RE: **Tract A-3-B (Legacy at Journal Center)**  
**Grading Plan**  
**Engineer's Stamp Date 4/26/17 & 3/29/17**  
**Hydrology File: D17D106A**

Re: Tract A-3-B (Legacy @ Journal Center) / Hydrology File D17D106A

**RE: Tract A-3-B (Legacy at Journal Center)**  
**Grading Plan**  
**Engineer's Stamp Date 3/29/17**  
**Hydrology File: D17D106A**

C-001

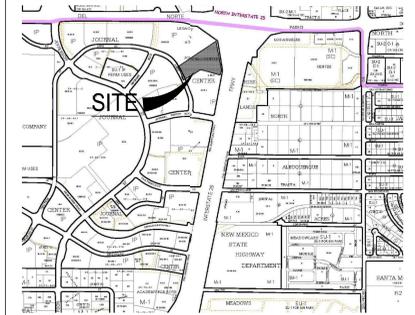
1. Provide an updated Drainage Management Plan (sheet C-001) that includes the limits of this project. Also include the revised limits and narrative for Basin B1-C that will now drain to Lang (this sheet was missing from the 4/26/17 paper submittal).
2. This project will require an ESC Plan to be submitted to the storm water quality engineer, Curtis Cherne, PE, prior to Building Permit Approval.

DRAWN BY	MHS
REVIEWED BY	MJB
DATE	April 27, 2017
PROJECT NO.	16-0068
DRAWING NAME	GRADING AND DRAINAGE PLAN

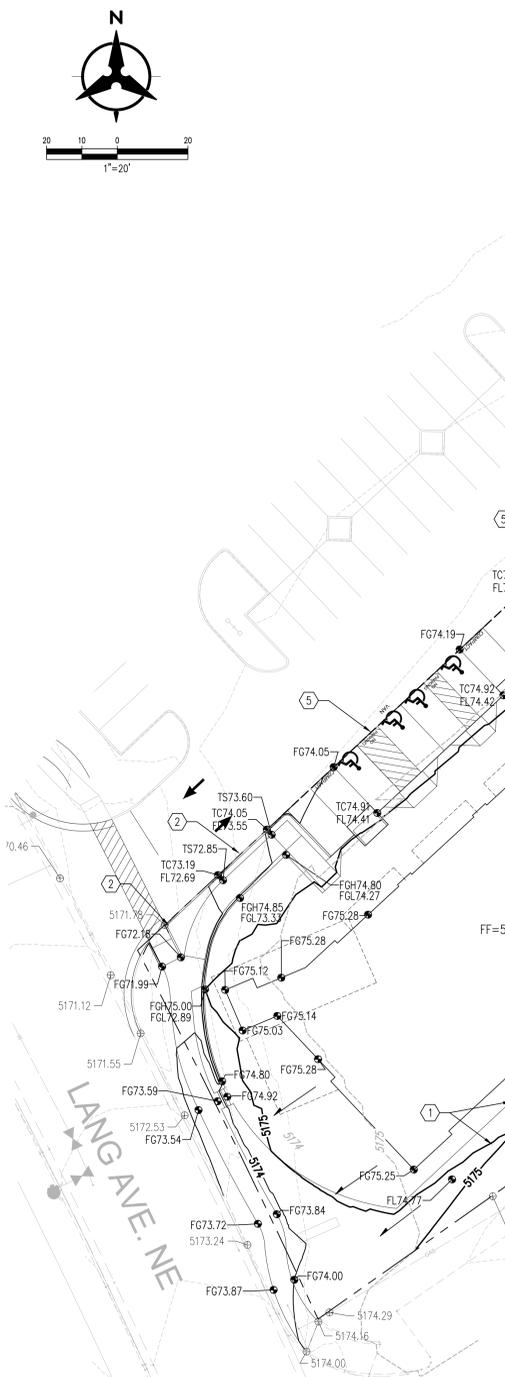
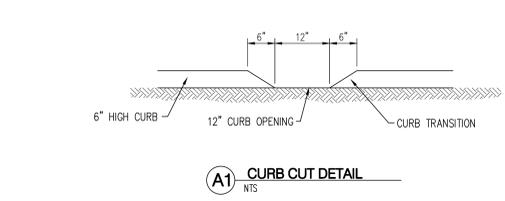
1. Provide flowline elevations along Pan-American to aid in the determination of waterblock requirements (0.67') at this location.  
*Response: Please see sheet C-101 for the existing flowline elevations along Pan-American.*

5. The northern portion of this tract is cut-off in the viewport on Sheet C101 and needs to be included if the grading will extend that far.

6. It's difficult to discern the extents of this project vs. others in the area. Screen-back and label the restaurant as not this project; clearly label/outline what area is included in this building permit.

*Response: Sheet C-101 has been updated to show all the limits of grading.*

*Response: The details of the existing improvements and the proposal have been adjusted accordingly and future improvements have been removed.*
